Garages 27a West End Lane

Delegated Report	OORT Analysis sheet		Expiry Date:	09/11/2016			
	N/A / attached		Consultation Expiry Date:				
Officer		Application Nu					
Fergus Freeney	2	2016/5031/P					
Application Address		Drawing Numb	pers				
Garages to the south of 27a West End Lane London NW6 4QJ		See decision no					
PO 3/4 Area Team Signa	ture C&UD	Authorised Of	ficer Signature				
Proposal(s)							
Demolition of the existing eight gatownhouses (Class C3) and asso	•	on of a two to t	hree storey terra	ce of 3x3bed			
	Grant Conditional Planning Permission Subject to a S106 Legal Agreement						
Application Type: Full Pla	nning Permission

Application Ref: 2016/5031/P

Demolition of the existing eight garages and the erection of a two to three storey terrace of 3x3bed townhouses (Class C3) and associated landscaping.

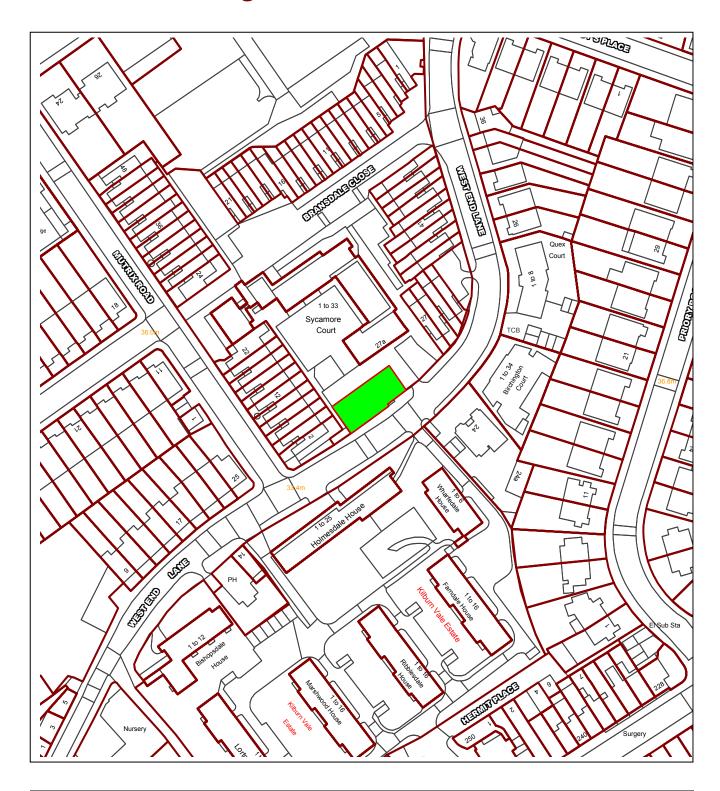
- 1.1. Permission is sought for the demolition of the existing 8x garages and the erection of a small terrace of 3x3bed townhouses and associated bicycle and bin stores with landscaping.
- 1.2. The townhouses would be of a contemporary design, constructed from buff brickwork with zinc clad set-back mansard type upper floors. They would be set back to back with the terraced dwellings on Mutrix road and contain gardens/yard to the rear.
- 1.3. The end of terrace house is wider than the other two and has been designed to provide an active frontage to West End Lane as well as to the primary frontage on the Sycamore Court side. A glazed slot in the rear elevation separates the West End Lane façade from the terrace

- 4.4. The proposal is a terrace of three, three storey, three bedroom houses which lie perpendicular to Sycamore Court, so helping to define a courtyard space between the two buildings. The proposed terrace stands lower than the eaves line of Sycamore Court because the site slopes away to the south and west. The houses are orientated back-to-back with the Mutrix Road properties and present a gable end to West End Lane that is broadly aligned with the gable end of the Mutrix Road terrace. This set back from the site boundary is an important consideration of the site layout as it creates a more rational building line, enables better sightlines on West End Lane for pedestrians and a more generous garden to the end of terrace house.

- 4.5. The houses are stepped back at the upper floor level to the rear to mitigate sunlight and daylight impacts to the Mutrix Road houses and this floor is slightly recessed behind a raised brick parapet. They are flat roofed buildings with green roofs to all main parts of the roof area. The main facing material is a light buff coloured Petersen brick to the ground and first floors and the walls enclosing the garden areas but the upper floor is clad in a roofing material, light grey vertical standing seam zinc, in contrast to the brick of the lower floors. This is an architectural device intended to reduce the perceived scale of the building as a whole by making it read as a two storey building with accommodation in the roof rather than a full three storeys. This approach is to some extent successful although it is the detailing of the brick elements of the building that contribute more to a sense of robustness and quality. These are simply detailed with deep reveals and pre-cast masonry copings, a string course and lintels. Large full height openings feature timber panels and panels of timber louvres in front of glazing to provide privacy where required.

- 4.6. The end of terrace house is wider than the other two and has been designed to provide an active frontage to West End Lane as well as to the primary frontage on the Sycamore Court side. A glazed slot in the rear elevation separates the West End Lane façade from the terrace, expressing the two distinct frontages to the building and creating views and outlook onto the street. This house has gardens to both the side and rear, enclosed by a low brick wall with

privacy landscaping and opaque glazed panels above. The other two houses have smaller rear courtyard gardens. Viewed from the street, above the boundary wall, the gable end elevation is expressed as a symmetrical composition formed of two large paired windows with opaque glazed Juliet balconies at first floor level.

- 5.2. The rear façade of the development would be approximately 9m from the rear façade of properties on Mutrix Road and windows would face each other on both facades; however, the proposal would incorporate 'slotted' window screening which only allows outlook in the direction of West End Lane, the residents of Mutrix Road would be presented with louvered windows with no apparent overlooking. This is considered to be an acceptable approach, a condition will be attached requiring details of these 'slotted windows' be submitted and permanently retained thereafter.

- 5.3. A similar approach would be taken at the front windows to prevent views into Sycamore Court; windows at third floor level would be obscure glazed and contain privacy louvres where necessary. This approach is considered to be an acceptable means to mitigate overlooking and privacy issues.

The stairwell window at first floor level on the north elevation shall be obscure glazed and non-opening.
